# Service Information

Category <b>K</b>	<b>Repair Guidance</b>	Ref. No. R062/14	Page 1 of 4
Coverage <input type="checkbox"/> Distributor only <input checked="" type="checkbox"/> Please inform your dealers		Date Issued August 4, 2014	
Please convey this information to your <input type="checkbox"/> Director <input checked="" type="checkbox"/> General Manager <input checked="" type="checkbox"/> Warranty Dept. <input checked="" type="checkbox"/> Parts Dept. <input checked="" type="checkbox"/> Training Dept. <input checked="" type="checkbox"/> Field Rep.		Date Revised	
Applicable Model  Mazda6 (GJ) with AT	Applicable Countries or Specifications  Worldwide

## Subject: AT Shift Lever is hard to move when shifting into P or other ranges

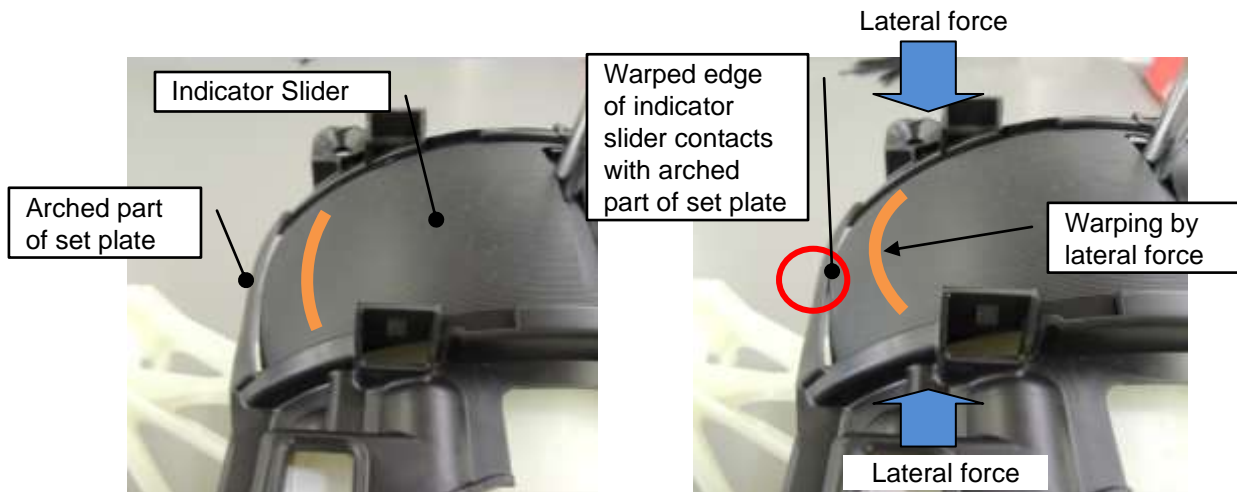
In case a lateral force, by touching of the passenger or driver's leg, is applied to the center console, the indicator slider may be deformed which causes the edge to contact with the arched part of the set plate when moving the AT shift lever. This may cause damage to the indicator slider and generate heavy AT shift lever movement.

### MASS PRODUCTION CHANGE

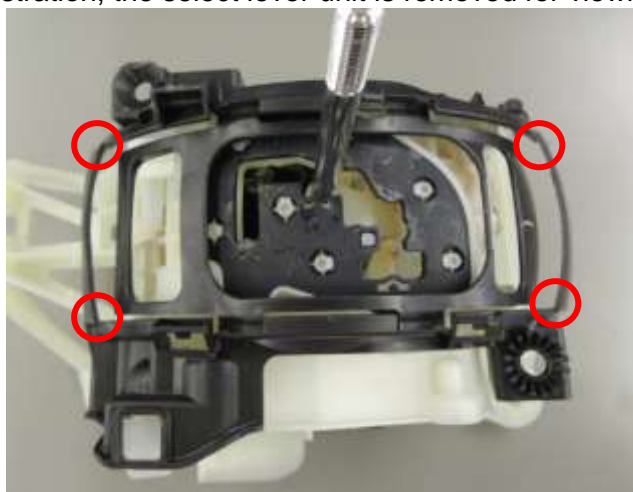
The following changes have been implemented to improve the strength and prevent interference between the parts.

1. The shape of set plate has been changed.
2. The shape of front console has been changed.

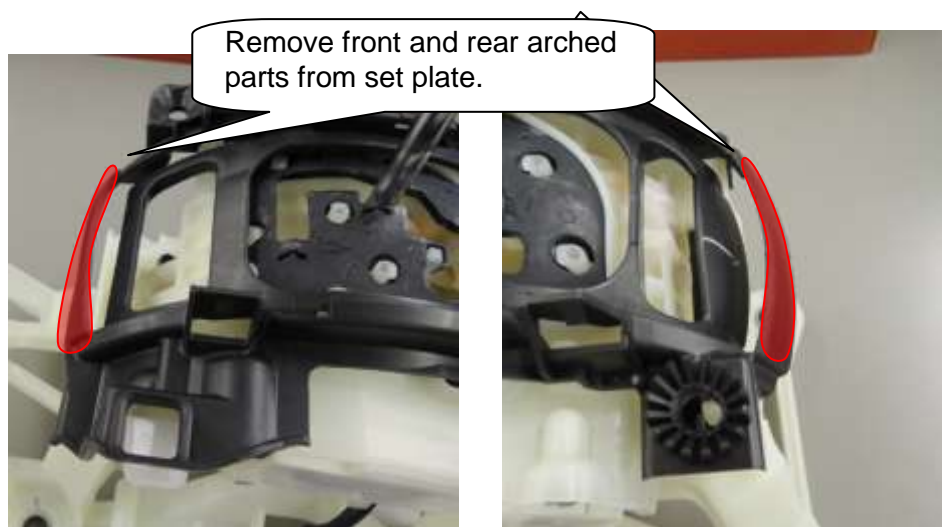
1. Verify customer complaint.
2. Remove the front console according to the Workshop Manual "FRONT CONSOLE REMOVAL/INSTALLATION".
3. Remove the old indicator slider and discard it.
4. With the set plate installed in the vehicle, cut off the front and rear arched parts.
  - 4.1 Cut the four areas indicated by circles in the figure using nippers.

**NOTE:** In the illustration, the select lever unit is removed for viewing purpose only.

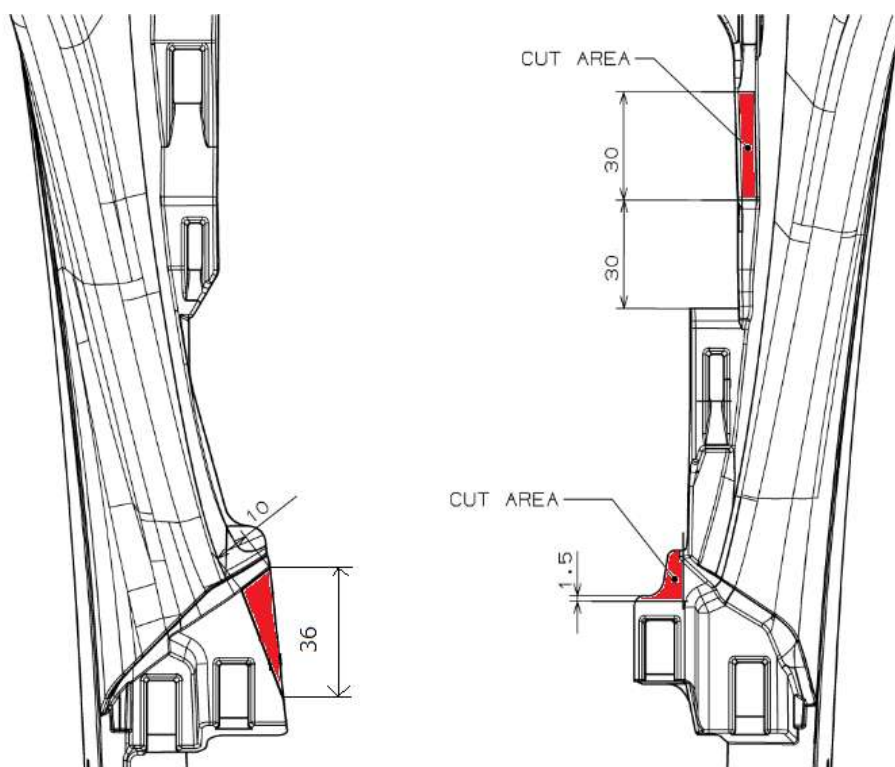
4.2 Remove off the front and rear arched parts from the set plate. (Red shaded parts in the figure.)

**-For L.H.D-**

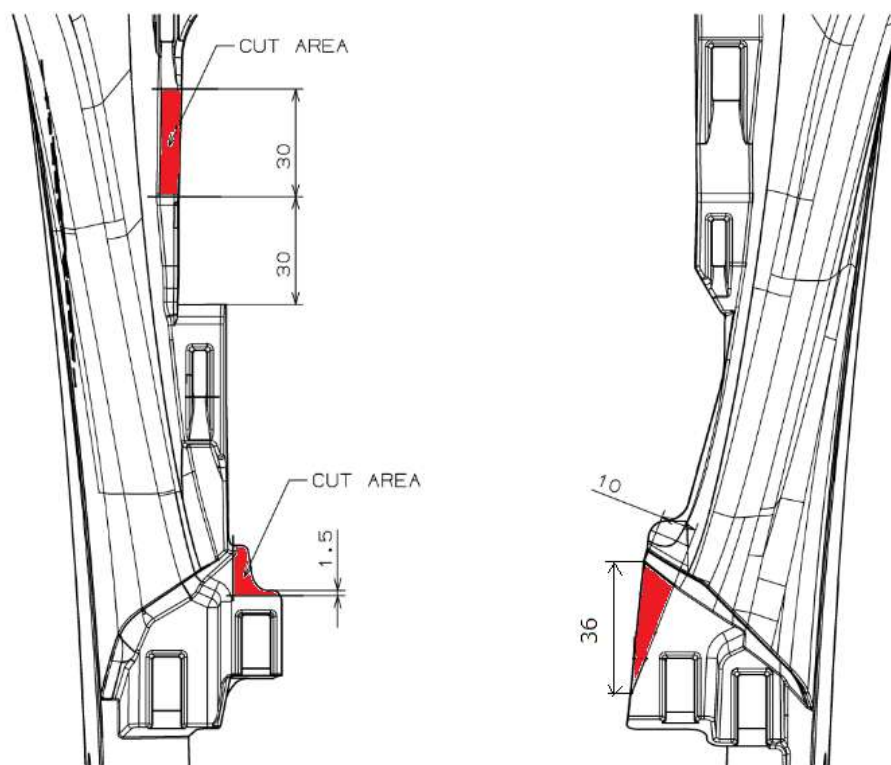
5. Cut off three pieces (indicated by red shaded areas in the figures) from the front console with a saw.
